Restricted substances according to S 132030-1	
Proposal supplier drawing	
Brake component	
SC	Classification of characteristics according to S 102012-1
material 16MnCr5 K+GKZ+LG acc. to S 130284	SC

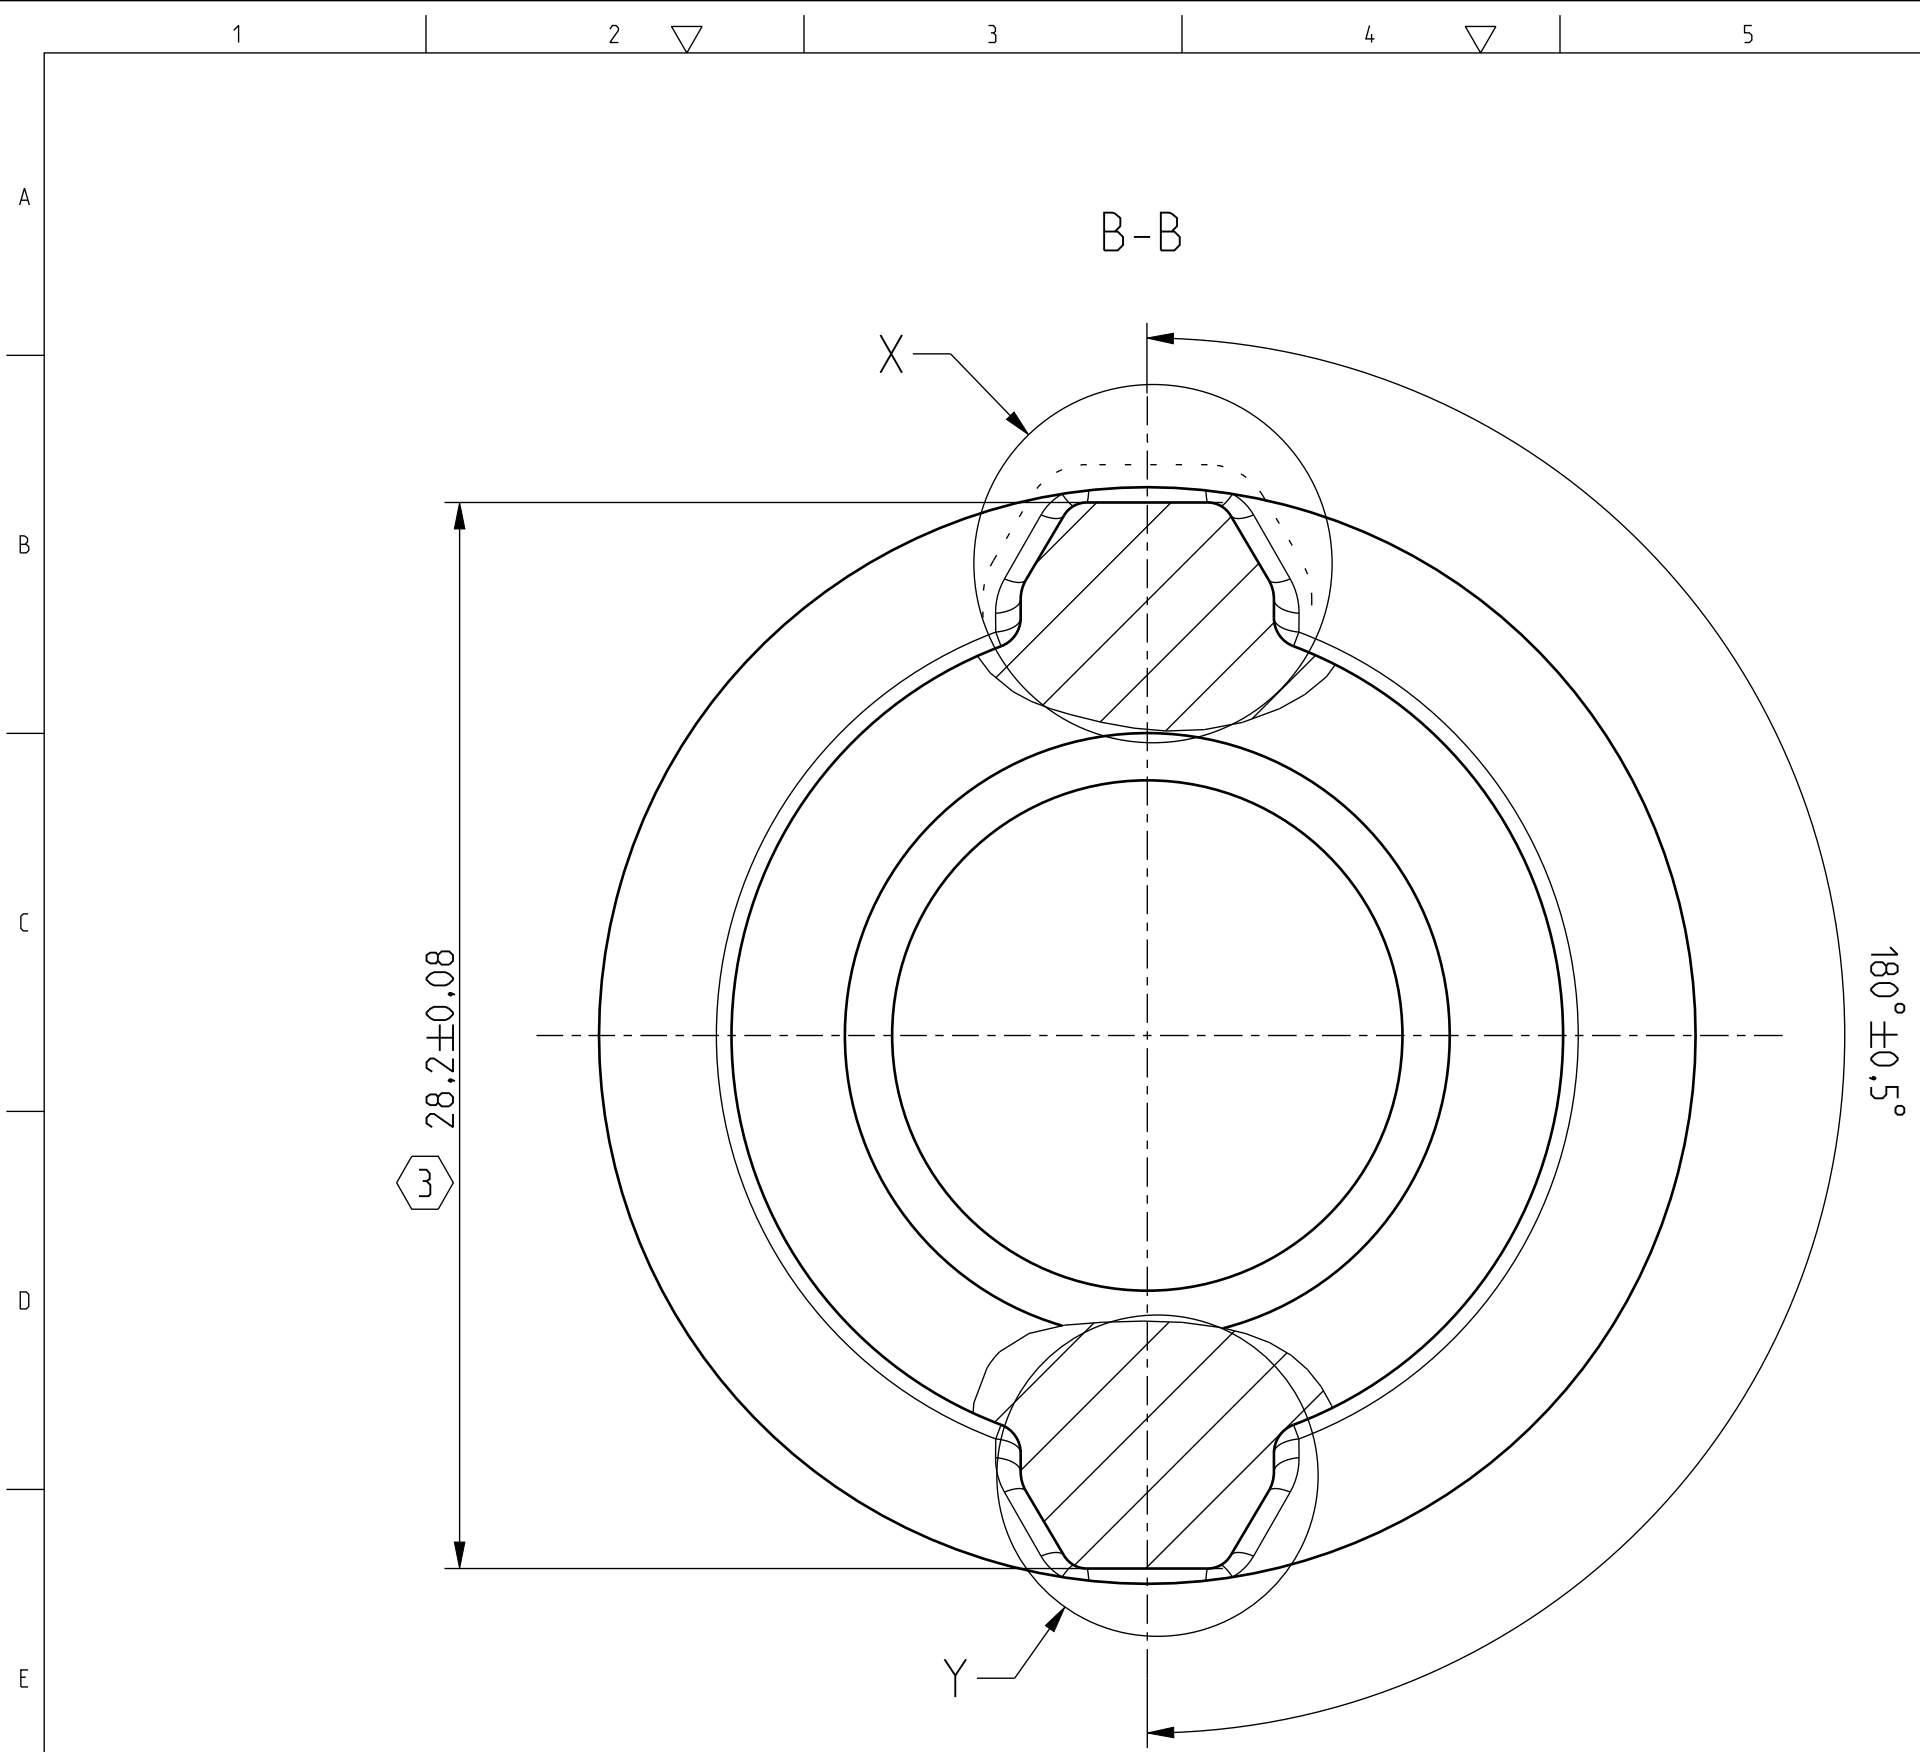
Add. Data / 추가정보			
Item / 자재코드		Ref. No.	Designation / 명칭번호
Tolerancing ISO 8015 제도통칙			
Version AB	Date 2026-05-07	Modification description / 개정기사 - Tolerances were increased for production	
Prev ver 구버전 AA	Modif. No. 개정번호 C218747	- Change : ø22±0.15 → ø22±0.1 for clamping, Width : 46.5 → 46	
Scale 척도 1:1		Description / 분류 Ball screw nut	Prep. by / 설계자 Ji Eun Jo
General tolerances 표기외공차 -		Additional description / 상세분류	Checked by / 검토자 Yong Su Kim
Mass approx. / 중량 약 89.91 g		Mater., semi-finished prod. / 반제품	
Sheet 페이지 1 / 1	Size 크기 A1	Proposal supplier drawing 공급업체 제안 도면	Document / 도면번호 EDS F-627894.15-0029-C04 X30
